# Updates to ONU MPRS state diagrams

Glen Kramer, Broadcom

# ONU MPRS Input Process

# #3: New Header Detection

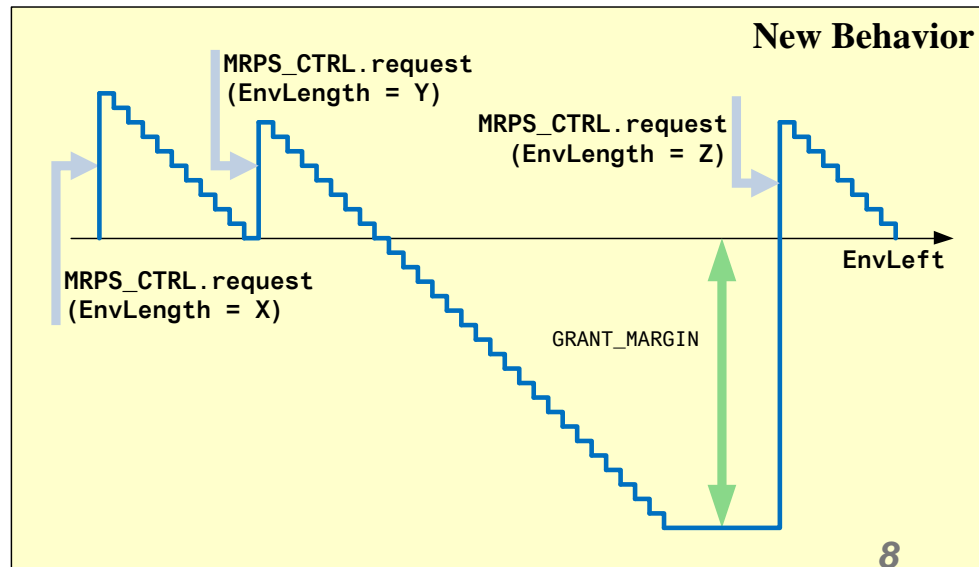
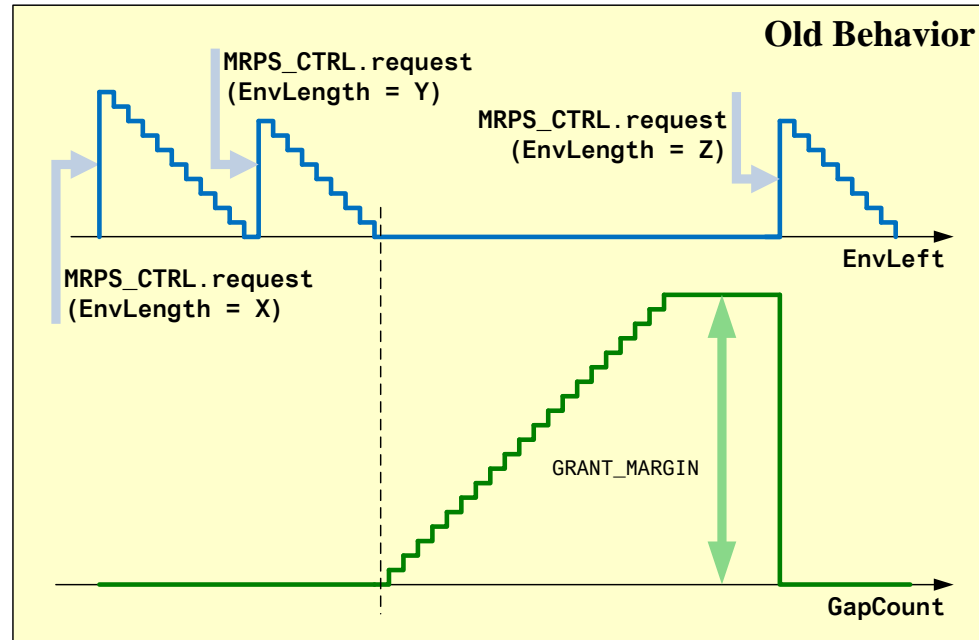
## ❑ Old behavior:

- A new envelope header is detected only when a given channel is free, i.e., if ***EnvLeft[ch] = 0***.

## ❑ New behavior:

- A new envelope header is detected even if previous envelope is still being transmitted.
- When a new header is detected, current envelope (if any) is terminated.

## ❑ Changes:

- Check for new header is moved ahead of the check for remaining envelope size (see transitions CHECK\_PARITY → CHECK\_HEADER → TX\_ENVELOPE\_HEADER)

# #6: TX\_FIFO Buffer Size

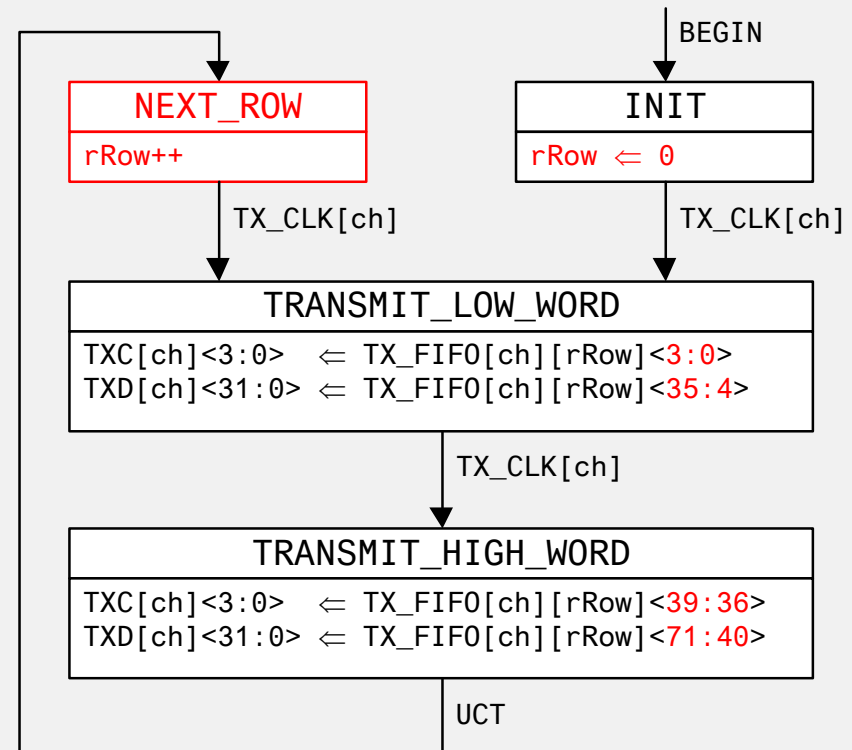
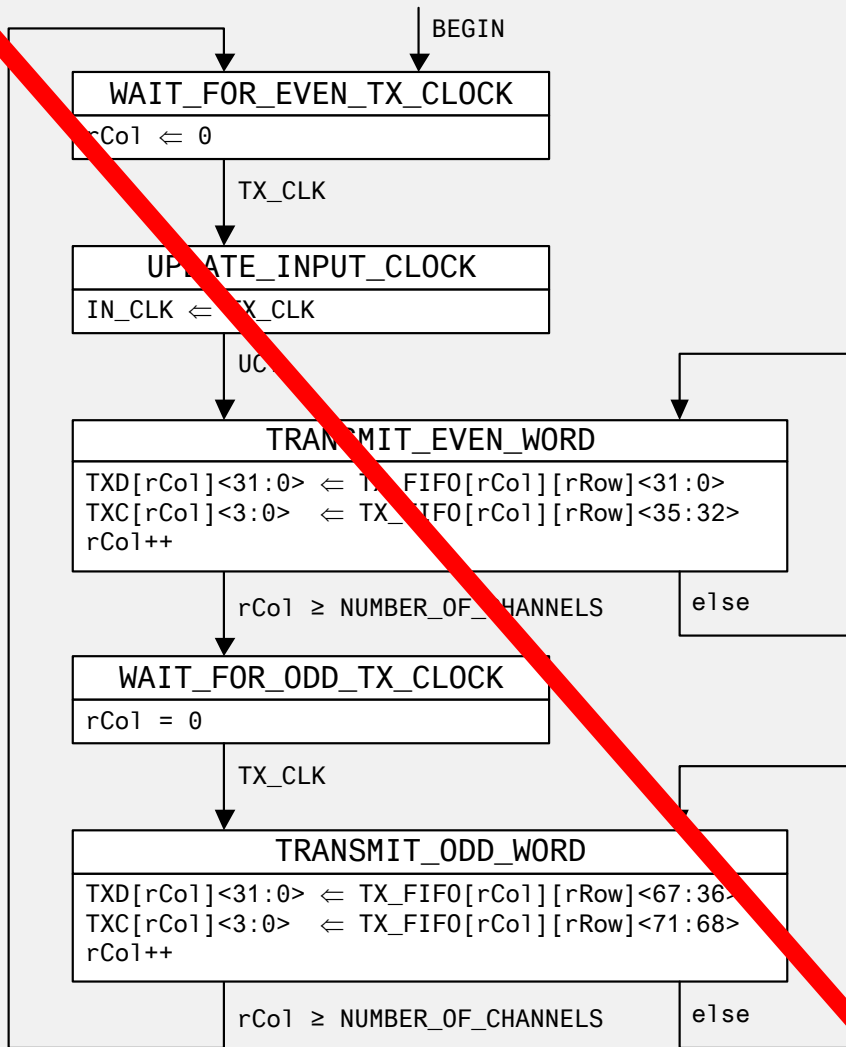
- It was previously mentioned (see [kramer\\_3ca\\_2c\\_0916.pdf](#)) that it would suffice for the TX\_FIFO buffer at the ONU to have only two rows
  - Total TX\_FIFO size = 2 rows x 4 column x 72-bits = 576 bits

Changes:

1. *wRow* variable is separated from the *EnvPam* variable.
2. *wRow* is a 1-bit integer that represents row index in the *TX\_FIFO* in the ONU.
3. *EnvPam* is 5-bit integer that represents row index in the *RX\_FIFO* at the OLT.

1. Rather than operating with link indices, the state diagram is changed to operate with link IDs (i.e., LLIDs).
  - This reduces the number of look-ups.
  - The ***LinkId*** value is converted into link index only once, inside the function ***GetMacBlock(...)***

# #1: Separate SD Instance per Channel

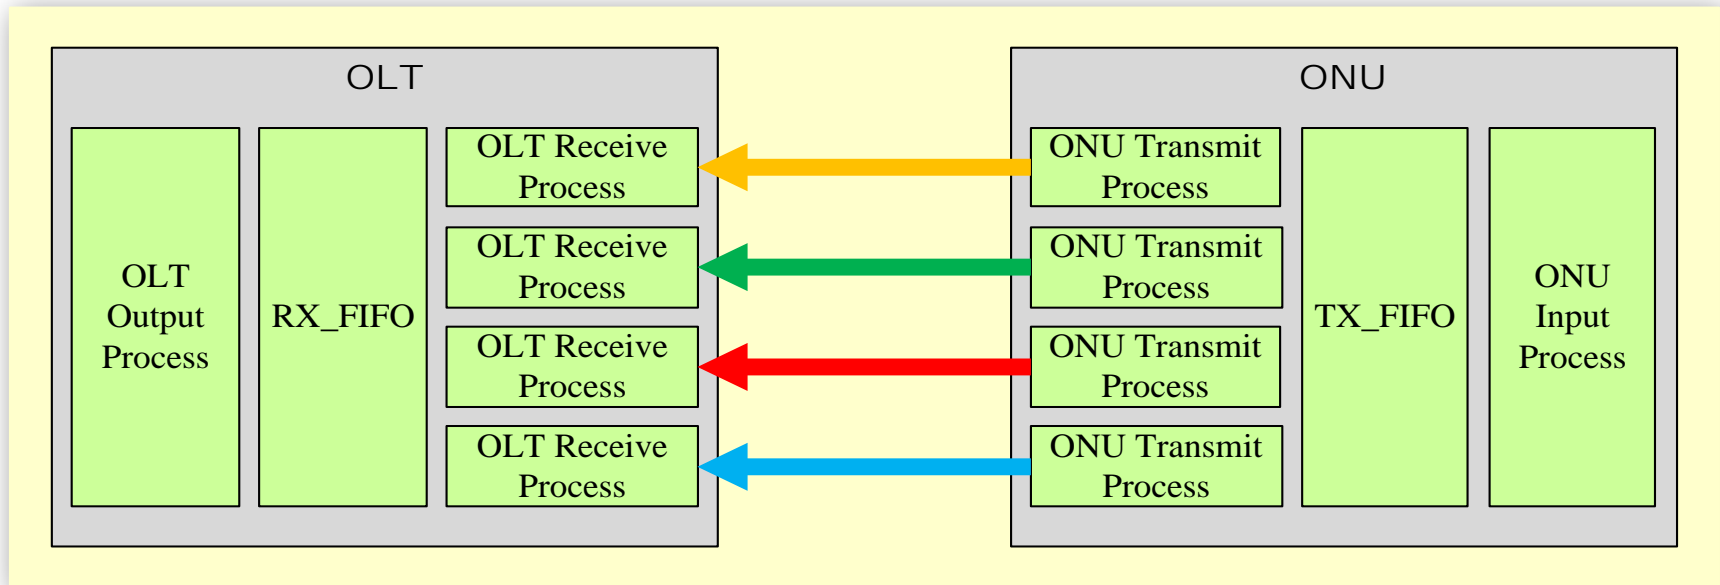
## ❑ Old Behavior:

- One instance of state diagram handled all four channels.

## ❑ New Behavior:

- The SD is changed to operate as a single instance per channel, to make it symmetric with the OLT Receive Process.  
(The OLT must have separate instances of the Receive Process because the RX\_CLK on every channel has a different phase.)

# #2: TX\_FIFO Buffer Size

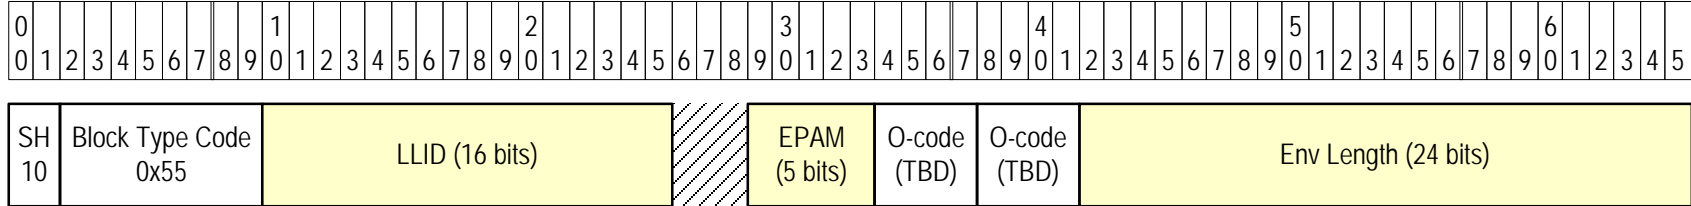
- **rRow** should be defined similarly to **wRow** (1-bit integer)

Changes:

1. Added initialization for **rRow**
  2. Added state NEXT\_ROW to increment **rRow** after every other 25GMII transfer.
- Note that while the **wRow** is initialized to 1, the **rRow** is initialized to 0. Both variables are incremented synchronously. Thus, while the Input Process writes into row 1, the Transmit Process reads row 0. Then, when the Input Process writes into row 0, the Transmit Process reads from row 1.
